**City of Richmond**  
Urban Development Division

## General Compliance Request

**To:** Development Permit Panel  
**From:** Raul Allueva  
Director of Development  
**Date:** December 13, 2004  
**File:** DP 04-010738  
**Re:** **Application by William Rhone for a General Compliance Request at  
7400 Heather Street**

General Compliance Drawings  
 Site Plan

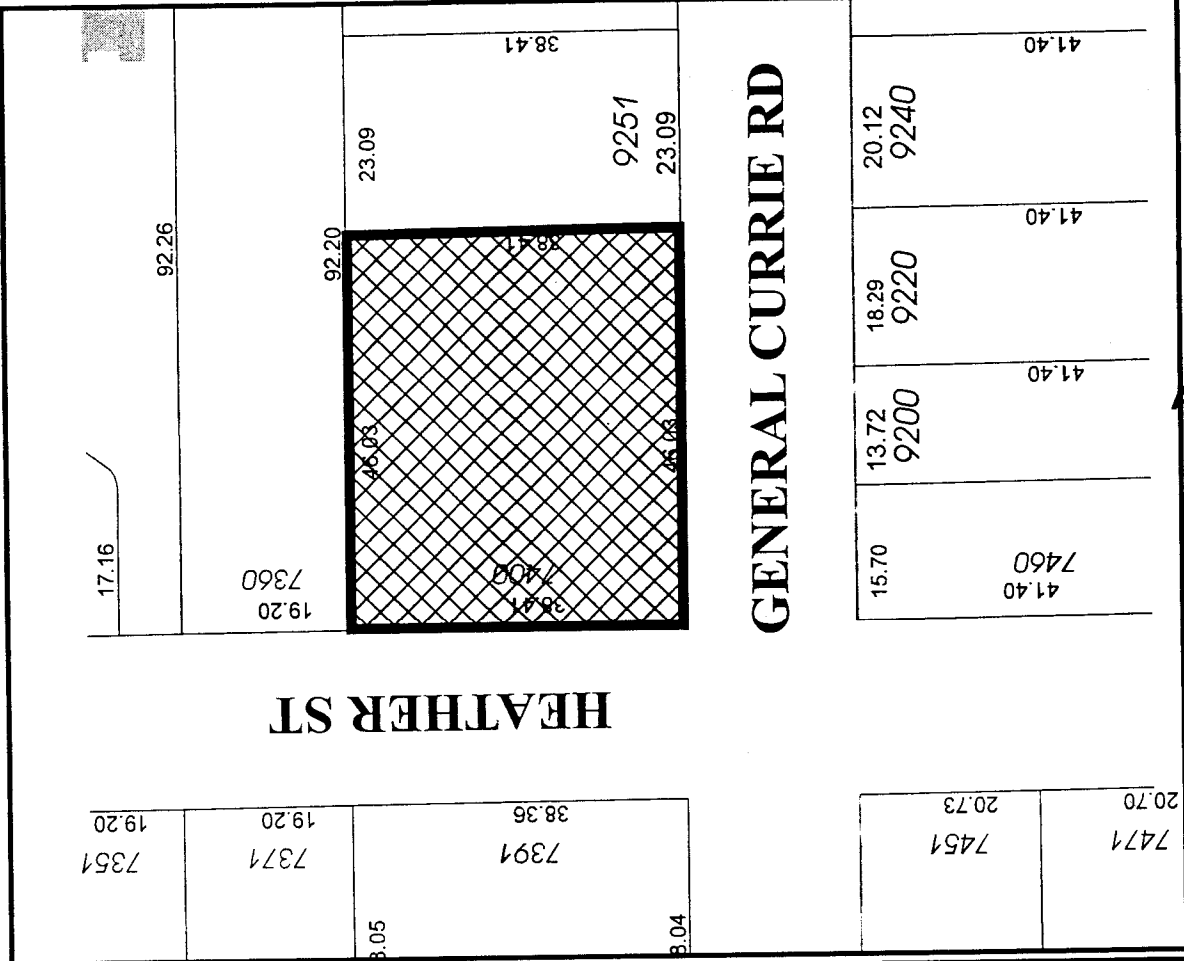
That the proposed changes be considered in General Compliance with the approved Development Permit (DP 04-010738) drawings for 7400 Heather Street, which covers minor revisions to the site plan and landscaping plan to allow sharing of the drive aisle and driveway access to the lane through the subject site for the neighbouring property to the east at 9251 General Currie Road.

Approved drawings for 7400 Heather Street show access to the site through a lane along the north property line with a connection to the internal drive aisle servicing the townhouse units. As both properties have been consolidated and are being redeveloped by the same developer/architect, the applicant is requesting revisions to allow vehicle access to 9251 General Currie Road through the internal drive aisle established at 7400 Heather Street. No legal agreements are necessary to facilitate this shared drive aisle as both properties have been consolidated.

- Proposed changes to the location and configuration of vehicle access and parking areas should be minor in nature. ***The revision to allow Phase 2 of the project to utilize the driveway access to the lane and drive aisle established through Phase 1 is minor and possible, given that both properties have already been consolidated into one (1) development parcel. Visitor parking stalls required for both phases of the development are being consolidated into one central area. The proposed shared driveway and drive aisle linking both phases results in an opportunity for more open space and landscaping in Phase 2.***

5 NOV 2004 ACCESS  
 PHASE 2 DELIVERIA  
 EAST PRO LINE

**General Compliance Drawings  
 Landscape Plan**

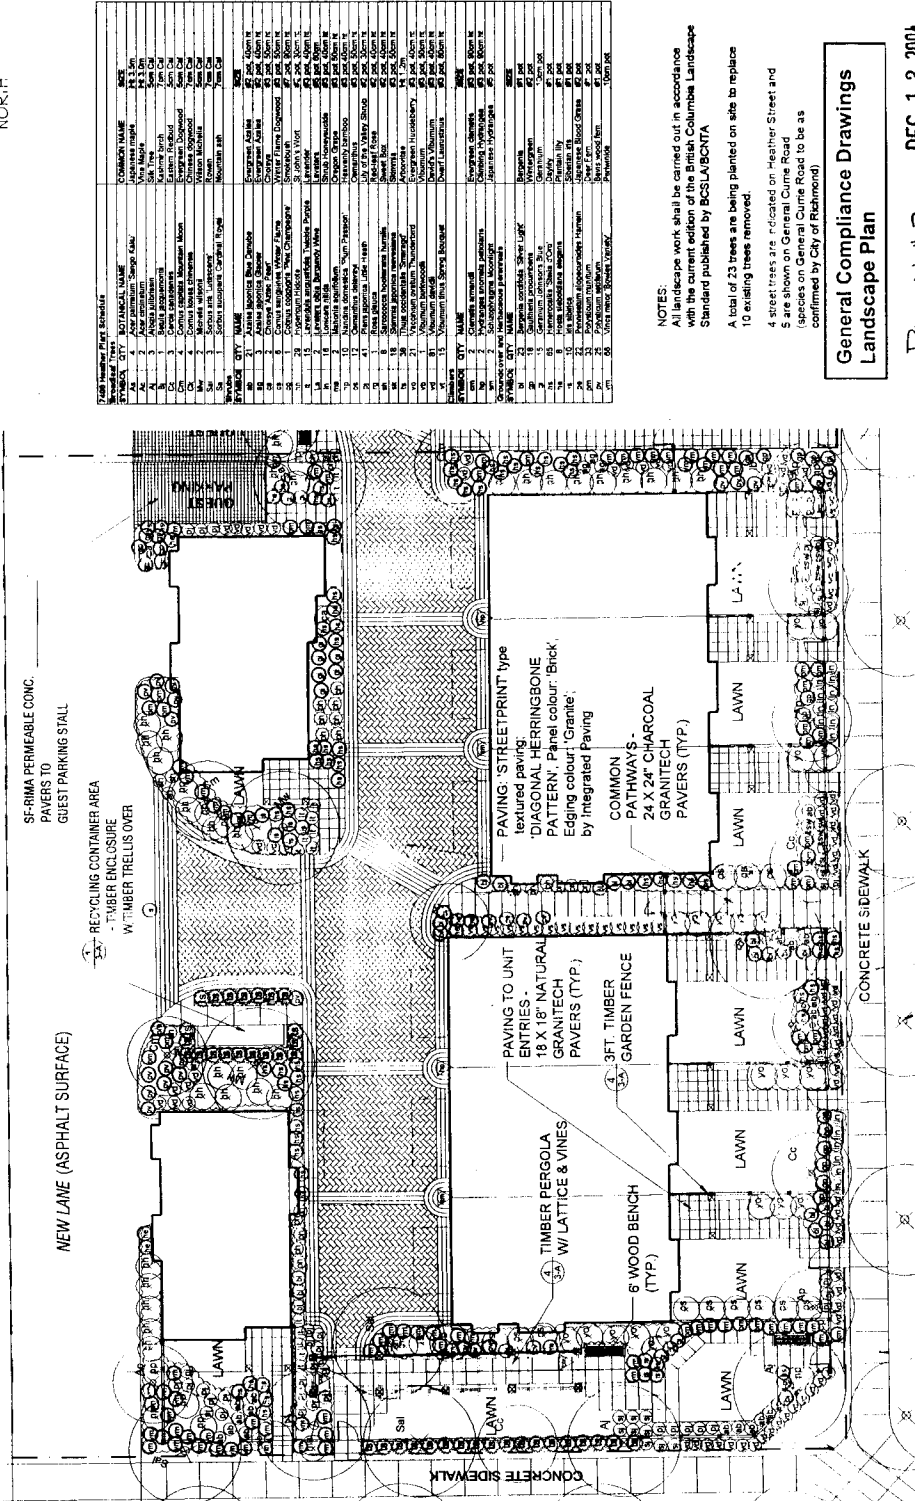
- Approved open space and amenity areas should be maintained; proposed changes to landscaping detail should be minor in nature and of equivalent value to approved plans. ***Revised landscape plans show that an identical paving pattern and treatment for the internal drive aisle is continued from 7400 Heather Street to the neighbouring site to the east. There has been no net loss of landscaping or open space as a result of the proposed changes. Landscaping has been implemented along the east property line of the subject site to complement the pedestrian walkway established as part of the 4-unit development in Phase 2.***
